**Village of Thiensville
Plan Commission
AGENDA**

**CHRIST ALONE 247 SOUTH MAIN STREET
CHRIST ALONE EVANGELICAL LUTHERAN CHURCH RESUBMITTAL
PLAN COMMISSION REVIEW**

To: Thiensville Plan Commission
Date: February 10, 2026

Applicant:	Geoff Grossman, Christ Alone Evangelical Lutheran Church and School
Status of Applicant:	Parish Administrator
Location:	247 South Main Street
Requested Action:	Building and Site Plan Review and Approval
Existing Zoning:	I-1

1 EXISTING MONUMENTAL SIGNAGE - FRONT/BACK ELEVATION
SCALE: 1 1/2" = 1'-0"

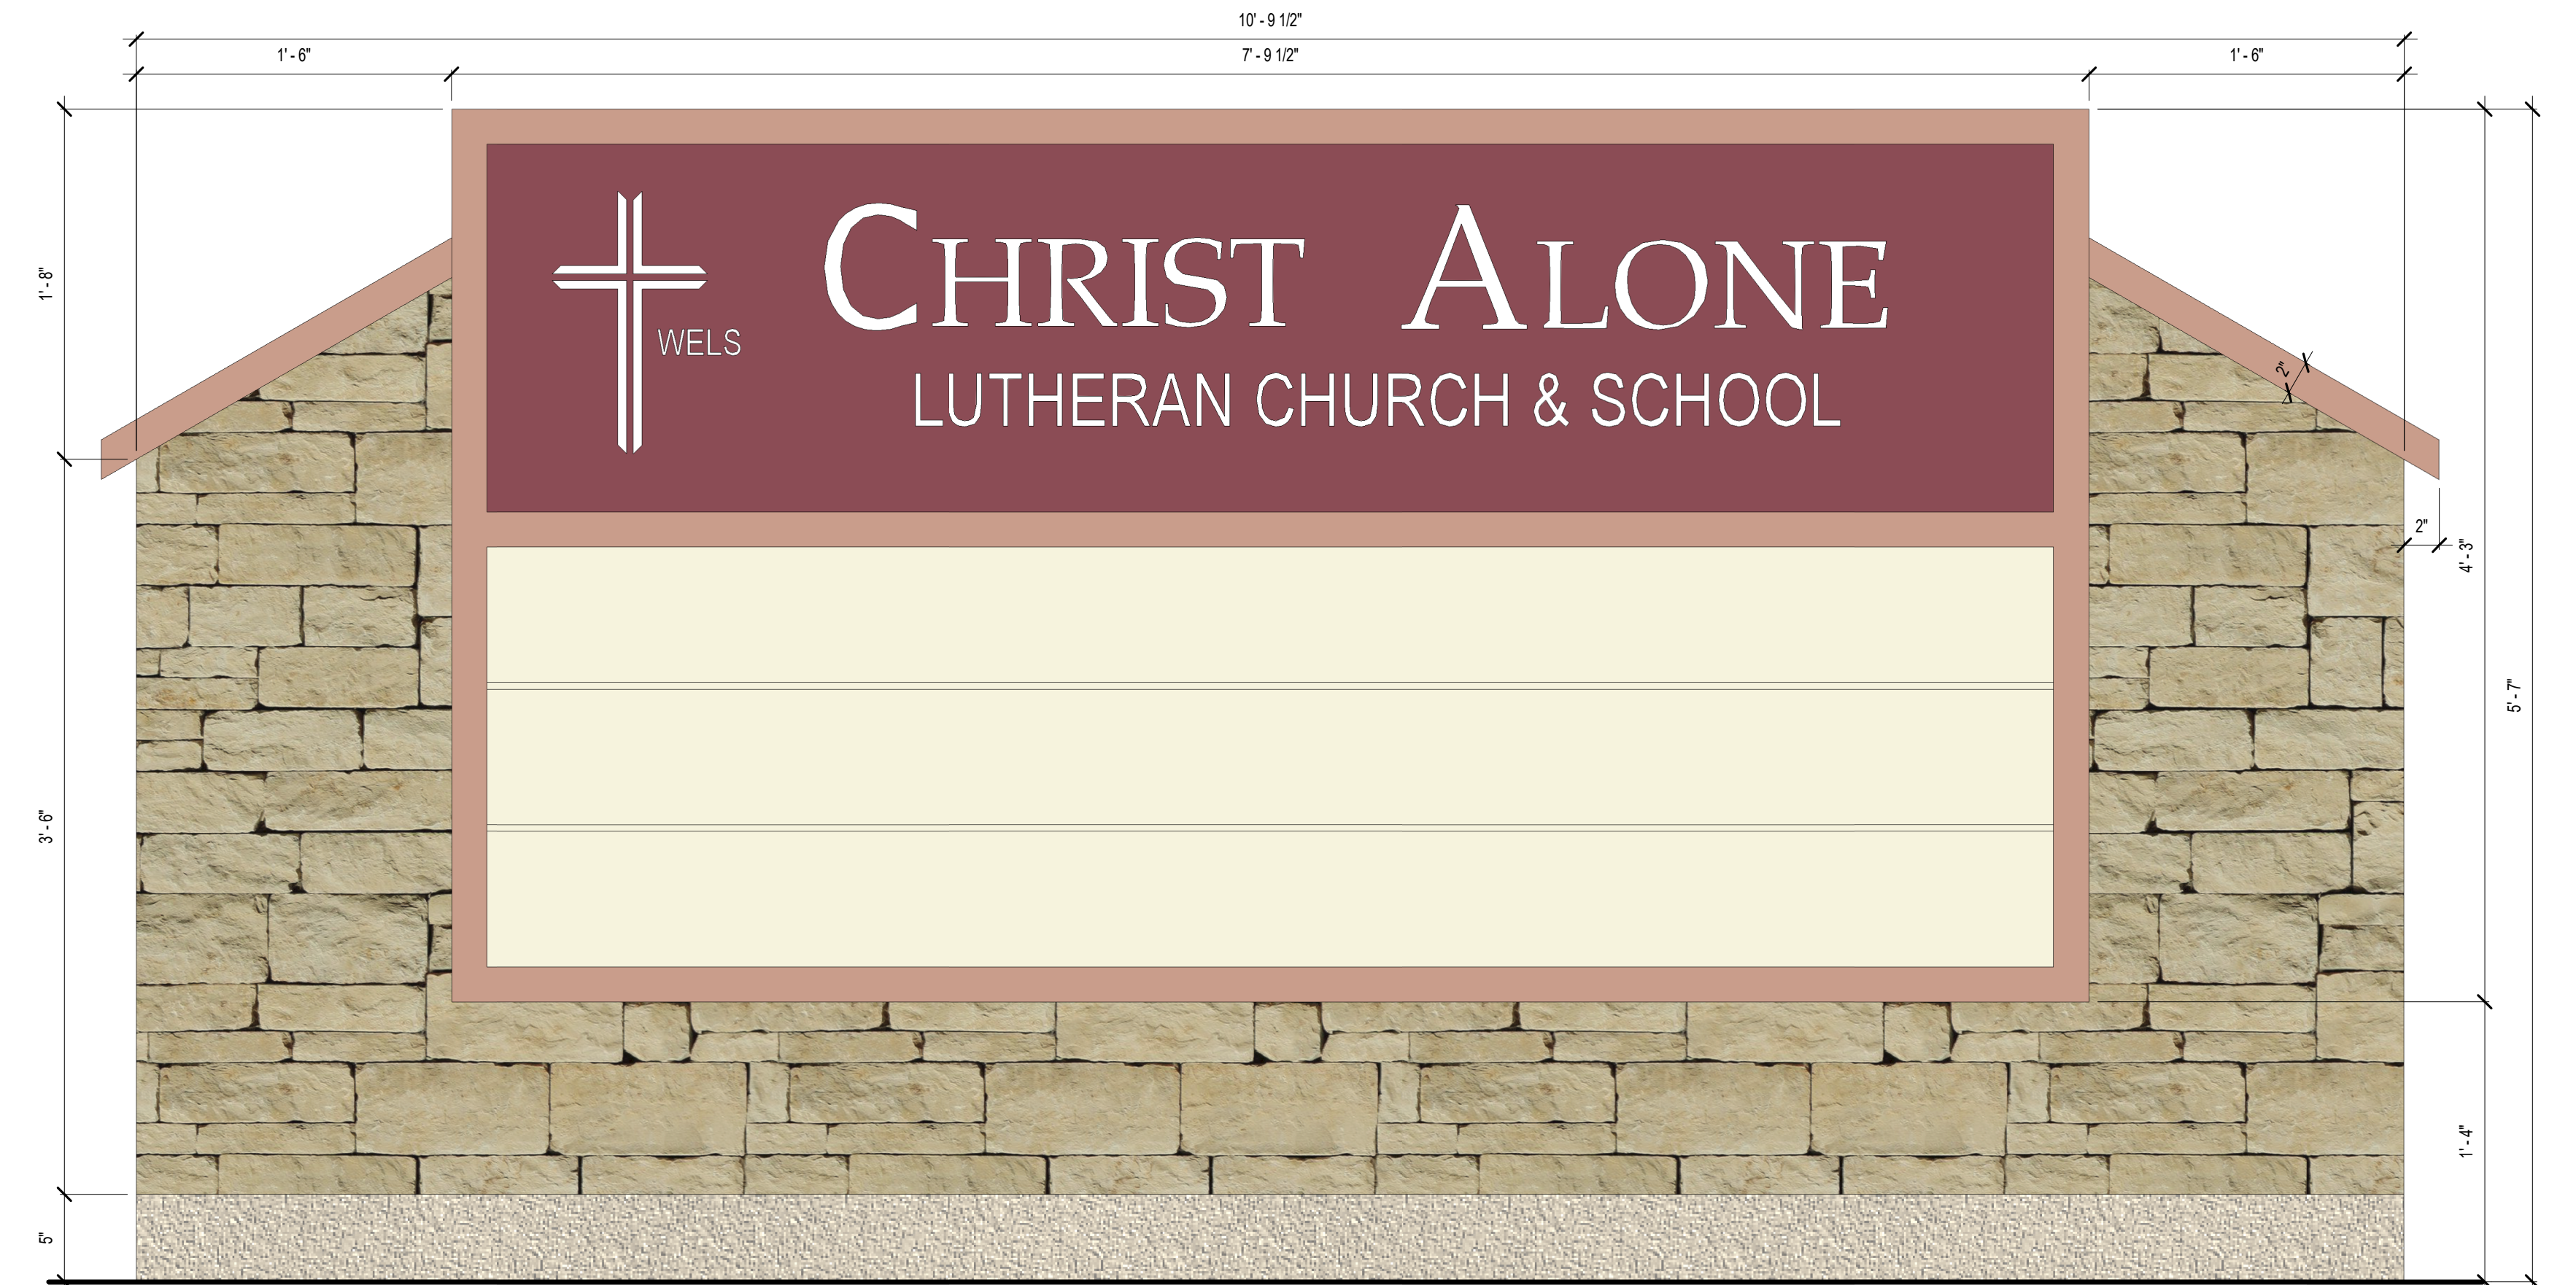
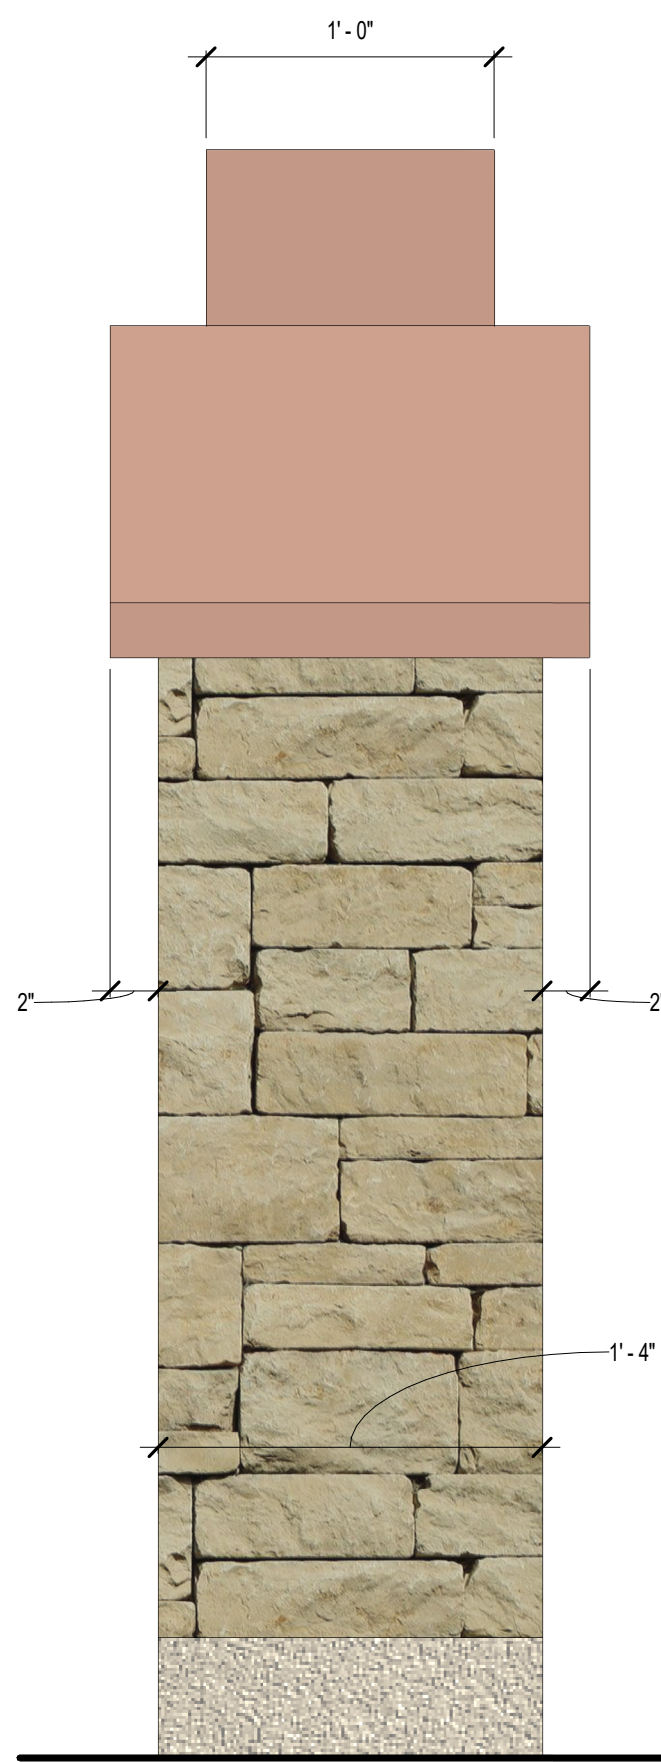
The applicant requests approval to relocate the existing monument sign to the proposed driveway on Main Street. The applicant also proposes 2 new wayfinding signs at the site's Division Street entrance. Staff request that the applicant submit a Sign Plan and permit application to describe the planned landscaping around the monument sign and the design, materials, and placement of the wayfinding signs.

5. Applicant shall provide a Sign Plan and permit application per the Village of Thiensville Sign Code.
6. Applicant shall comply with all Engineering comments provided in June 2025.

- e. Applicant shall provide a Sign Plan and permit application per the Village of Thiensville Sign Code.
 - f. Staff recommend the applicant provide a complete Sign Plan and permit application prior to construction permitting.

DESCRIPTION: PROPOSED SITE PLAN

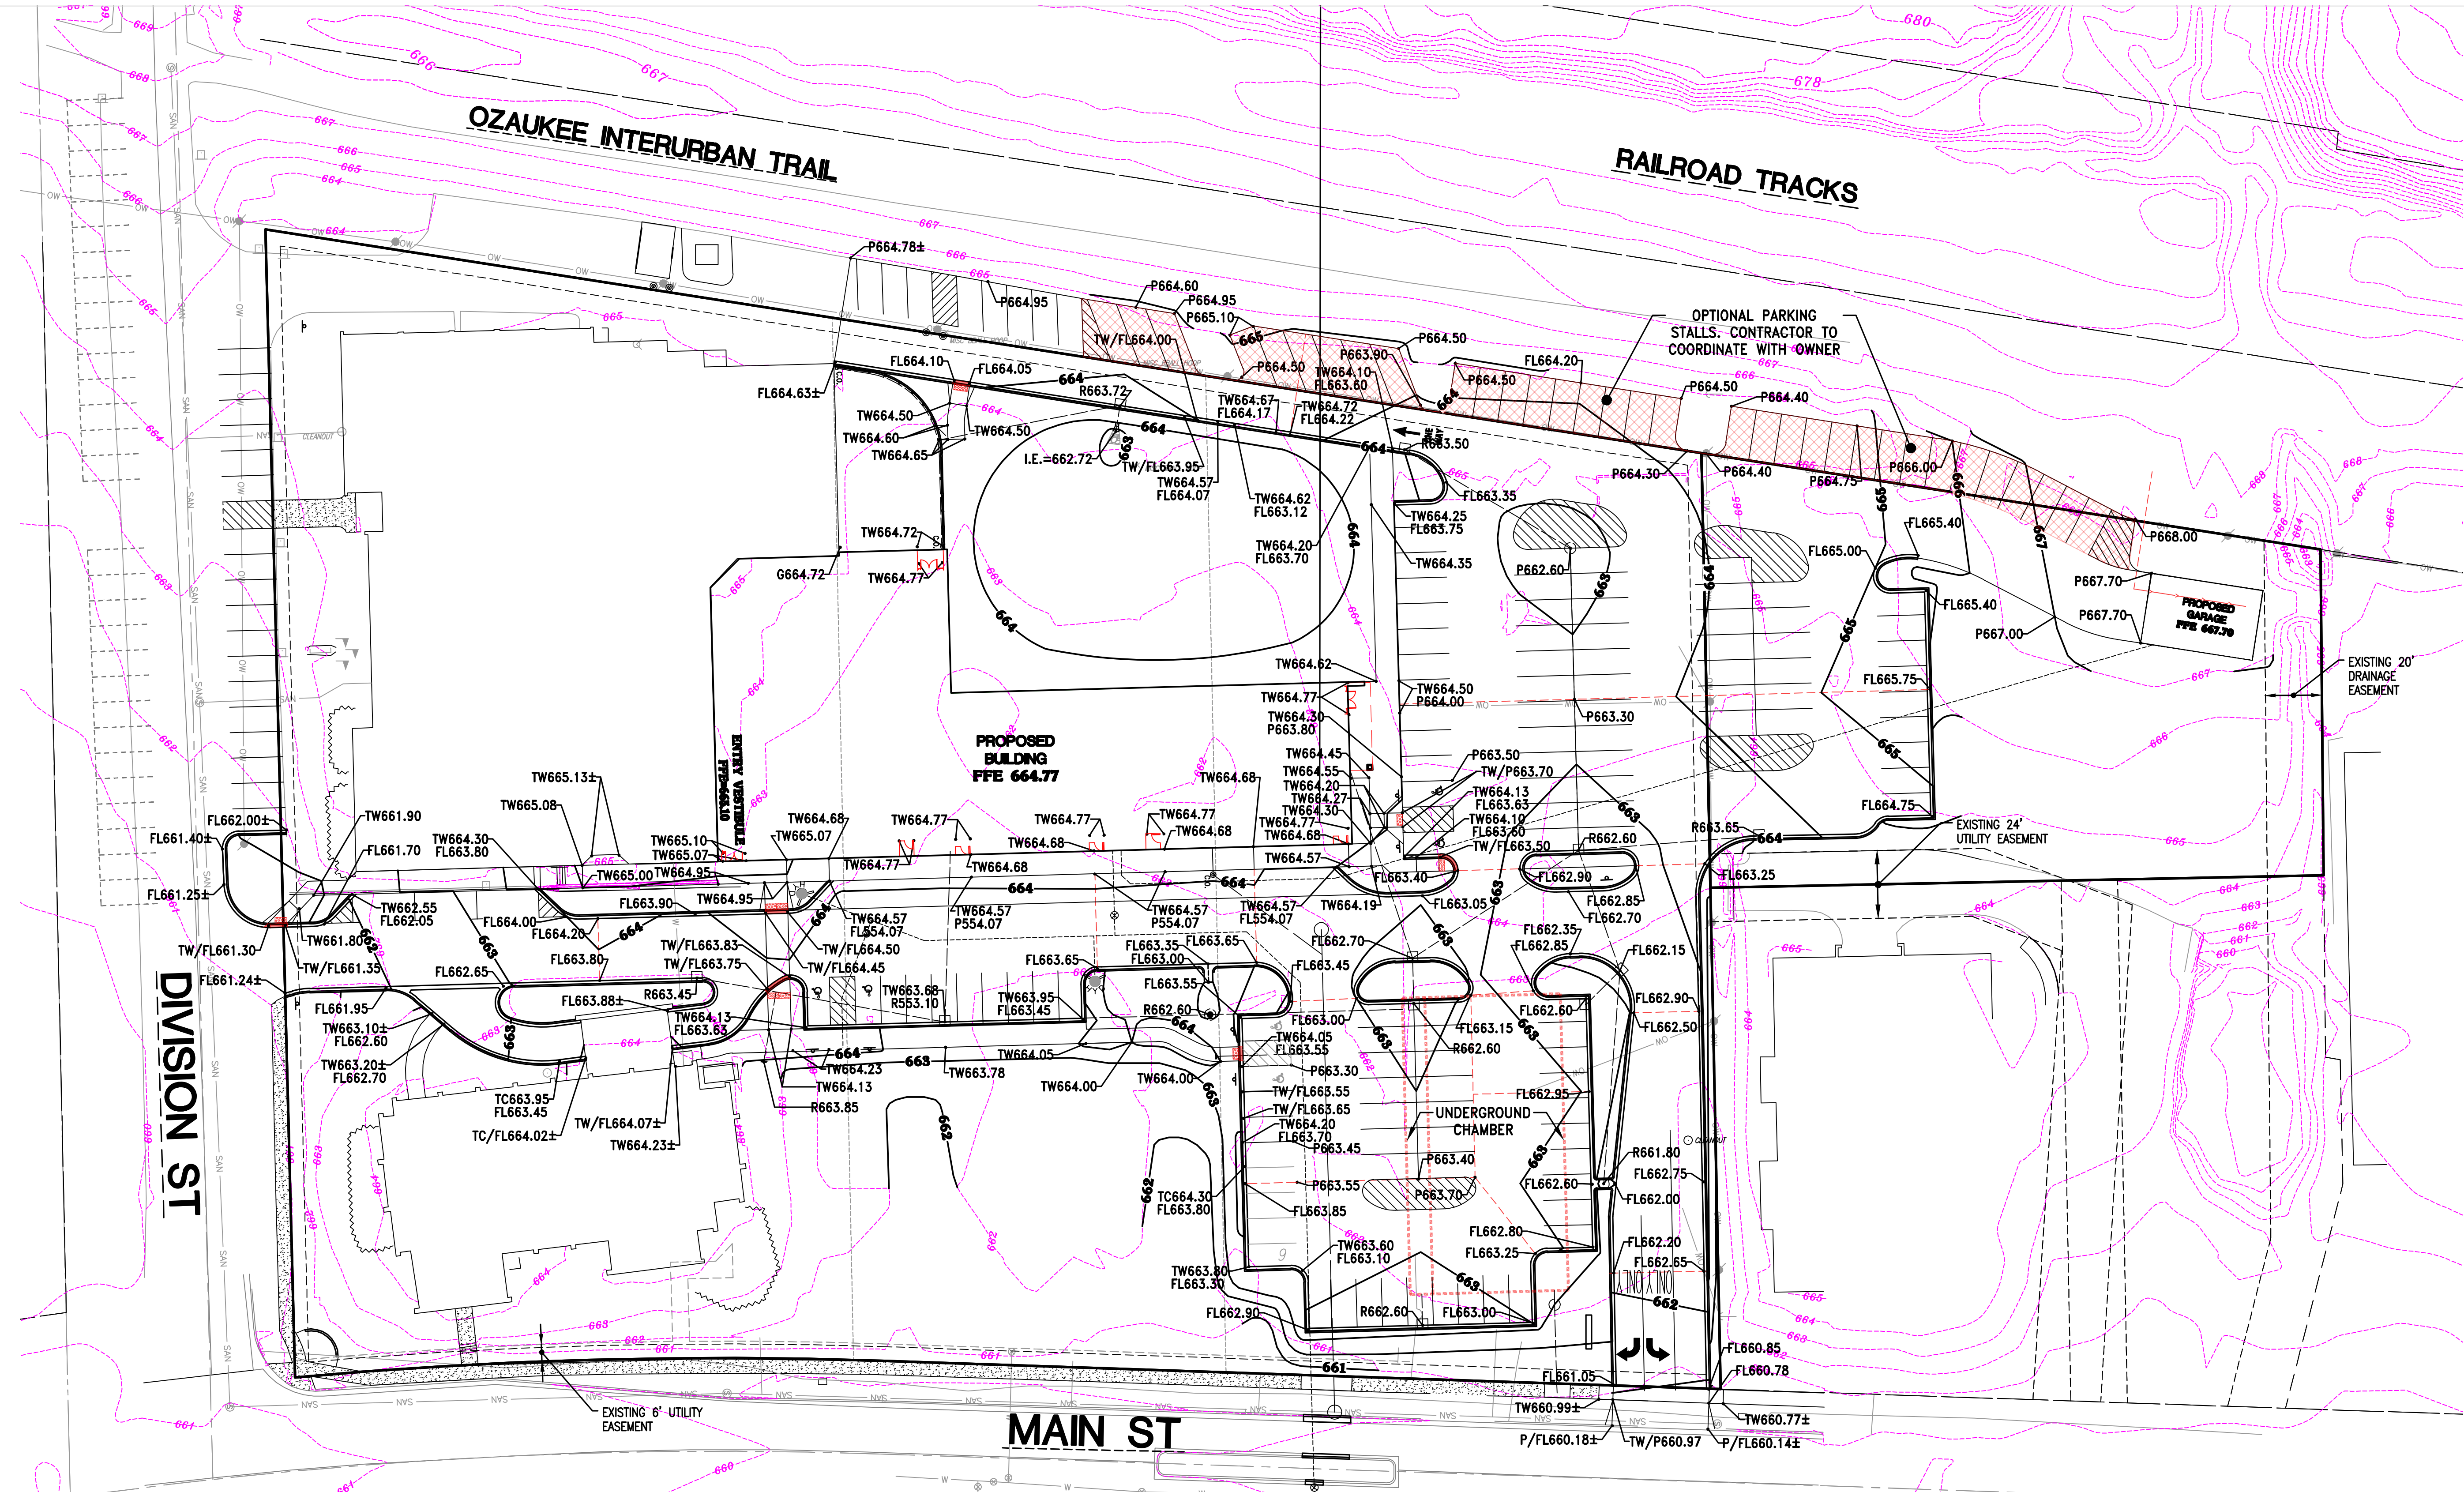
The updated plan now shows an outdoor play area on the north side of the site, adjacent to the parking area. Play equipment is often considered an accessory structure; the applicant is not proposing any play equipment at this time. If that changes, the applicant will be required to return to the Plan Commission for site plan approval. Additionally, Staff request the applicant confirm if basketball hoops are intended to be installed in the hard-surface play area.

The applicant previously provided a queueing exhibit, illustrating the pickup/dropoff circulation pattern. This plan is unchanged in the submittal. According to the exhibit, 60 vehicles can queue in a double stack around the parking area on-site without impacting traffic on Main Street. Additionally, the proposed Main Street drive will be an entrance only during dropoff and pickup times, limiting congestion on Main Street at peak times.

The proposed parking area landscape plan differs from the Zoning Code, proposing landscape areas in the parking area of 8.8% rather than the 10% required in the Code. This reduction in landscaping allows for the parking lot play area and the ability to maintain safety and visibility. Staff recommend allowing for this modification, per Section 17.0503.G.

The proposed landscaping plan also illustrates screening of the parking area. The parking areas, garage, and play area will be appropriately screened from the residential uses to the north. Screening requirements for the Main Street frontage requires a masonry wall with plantings at the sidewalk. The proposed landscaping plans do not indicate a masonry wall or plantings in front of the parking area. The applicant has indicated that modern school safety standards prioritize site lines and visibility. Staff are comfortable with modern design and safety standards for schoolyards and parking areas, but would like to work with the applicant on some low landscaping to soften the parking edge fronting Main Street. The proposed light poles meet the Code height maximums and will be cutoff type fixtures as required. As part of the demolition and site work plan, Staff request that any existing trees along the Main Street frontage that can be saved are preserved to maintain a level of screening during the construction process and in the interim before the Phase 2 construction begins.

3. Applicant should work with Village staff to address parking area screening requirements, including low plantings along Main Street frontage.
4. Applicant should work with Village staff to confirm all proposed luminaires comply with Village code standards, including maximum wattage and maximum illumination at the southern and southeastern property line (less than 2 candlefoot).

- c. Applicant should work with Village staff to address parking area screening requirements, including low plantings along Main Street frontage.
 - d. Applicant should work with Village staff to confirm all proposed luminaires comply with Village code standards, including maximum wattage and maximum illumination at the southern and southeastern property line (less than 2 candlefoot).

- g. Applicant shall comply with all Engineering comments provided in June 2025.
 - h. Applicant must return with site plan design and specifications related to any play area equipment in the future.
